UNITED STATES PATENT AND TRADEMARK OFFICE

Office Action Summary

10/749,206

CHOI, KEE-HOON

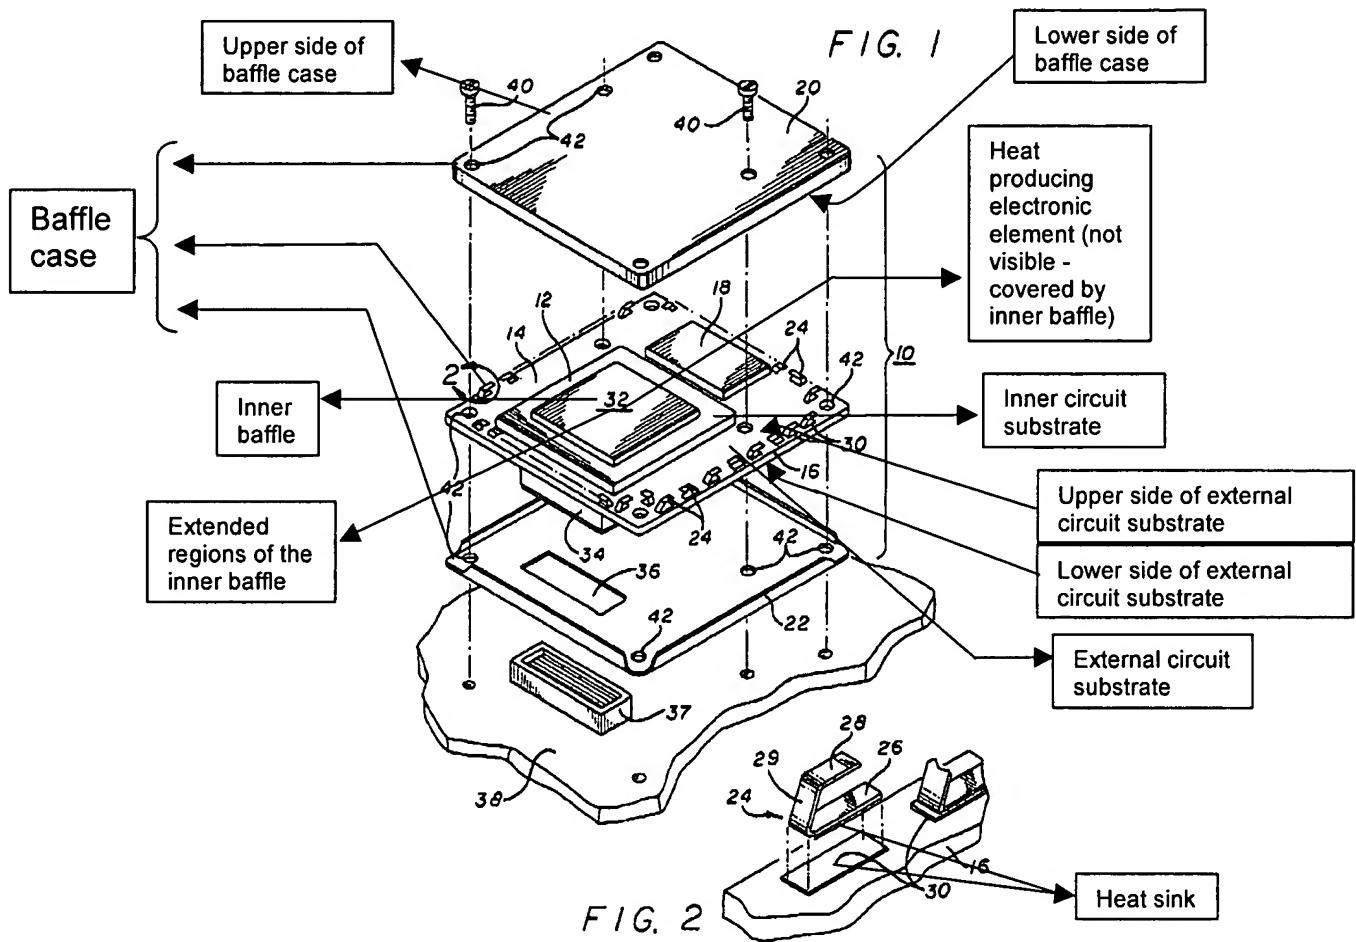
Taylor et al. disclose a cooling structure for an electronic element, wherein the structure comprises: an extended portion formed on an inner baffle (32) and contacting an upper surface of a heat-producing electronic element (column 1, lines 19-20), wherein the inner baffle and the heat-producing electronic element are mounted on an inner circuit substrate (12); a baffle case (made up of 20, 24 and 22) surrounding the inner baffle, the extended portion, the heat-producing electronic element, and the inner circuit substrate, the baffle case having an upper side and a lower side (marked in the figure); and a plurality of baffle case holes through the lower side of the baffle case.

While Taylor et al. does not explicitly disclose the inner baffle and the inner baffle contacting the heat-producing electronic element, it would

have been obvious for the microprocessor to be in contact with the inner baffle 32 in order to allow the heat from the processor to be removed from the system (column 1, lines 19-23).

Taylor et al. do not disclose a plurality of through holes formed on the inner circuit substrate underneath the heat-producing electronic element, or a radiating plate mounted on the upper side of the baffle.
